JANUARY 2017
AMENDMENTS
TO
CITY OF ROSEVILLE
DESIGN AND CONSTRUCTION STANDARDS
JANUARY 2016
EFFECTIVE JANUARY, 2017

The following highlighted amendments represent minor revision to the “January 2016 Design & Construction Standards”. These amendments supersede the prior document and will be formally edited and incorporated into the “2016 Design & Construction Standards”. Therefore, it is recommended all standards plan holders insert this packet into the front of the “January 2016 Design & Construction Standards” and refer to them as necessary.

Marc Stout
City Engineer

**EXHIBIT 7-1
 LEFT TURN SIGHT DISTANCE:**

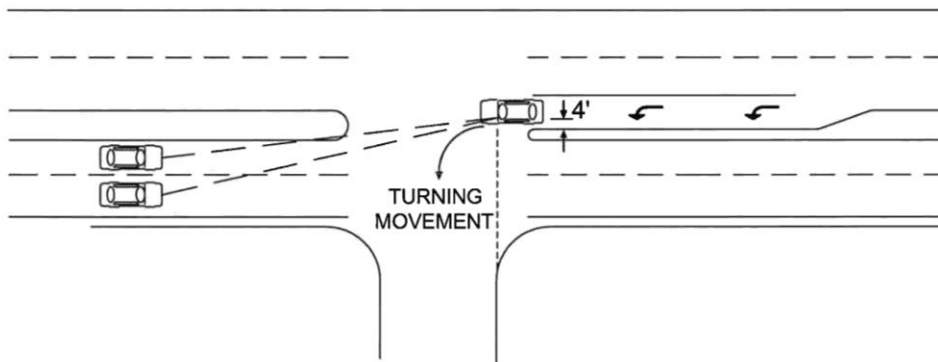
Sight Distance is based on a 3.5 foot height at the location of the driver and a ~~4.25~~ 3.5 foot object height in the center of the approaching lane of the major road. The left turn driver measurement is taken 4 feet from the left edge of the turn lane at the projected edge of the curb return (as shown above). If the major road is a multi-lane road, the controlling measurement for sight distance shall be based on the approach lane that is the worst case scenario.

~~STREET NAME SIGNS~~
BIKE LANE STRIPING A

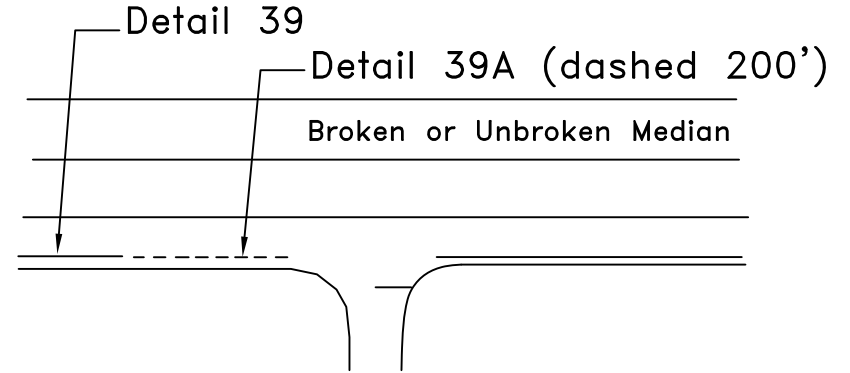
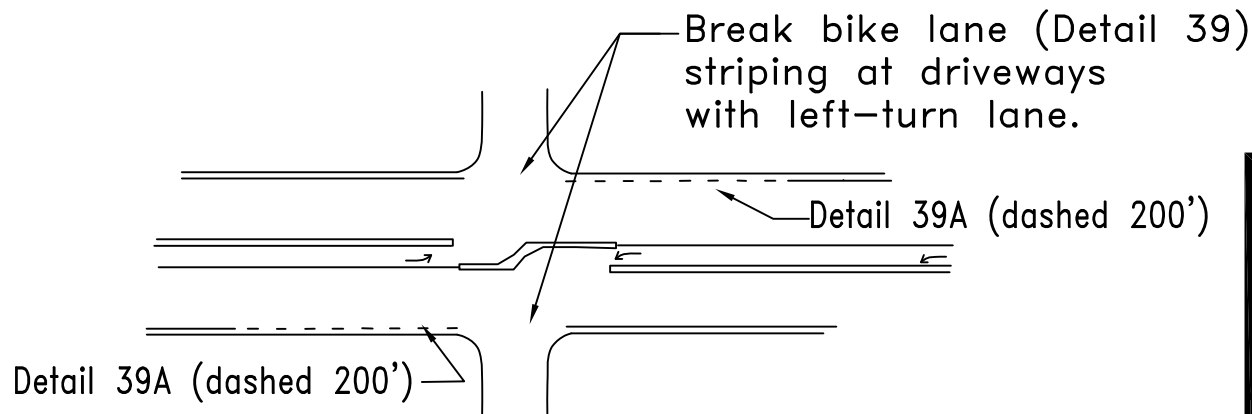
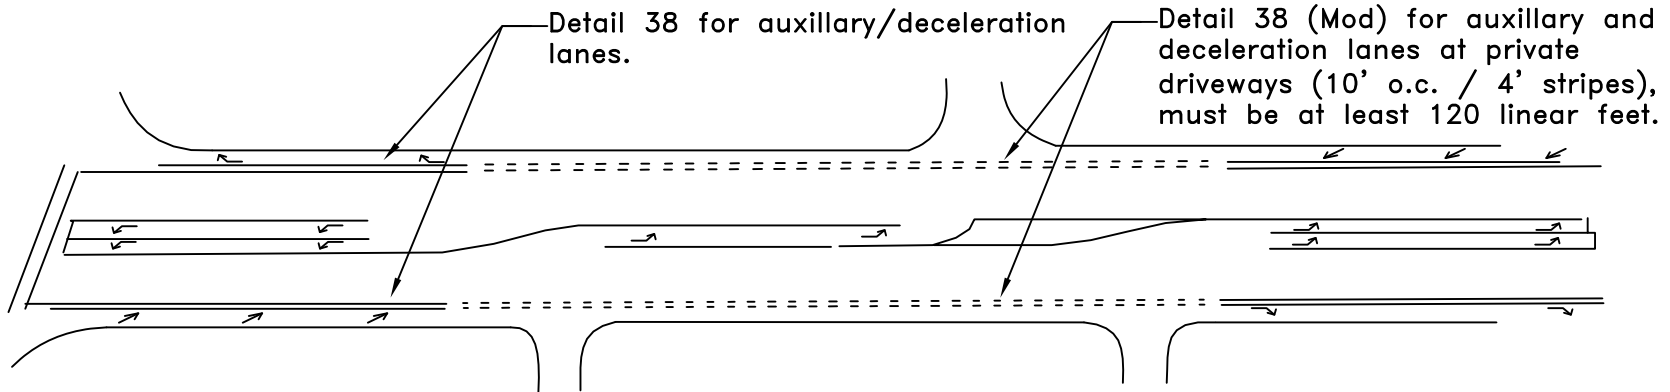
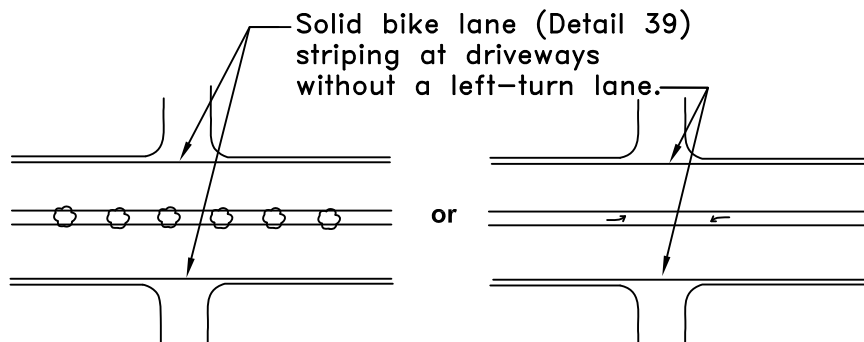
Extend bike lane (Detail 39) to the signalized intersection.
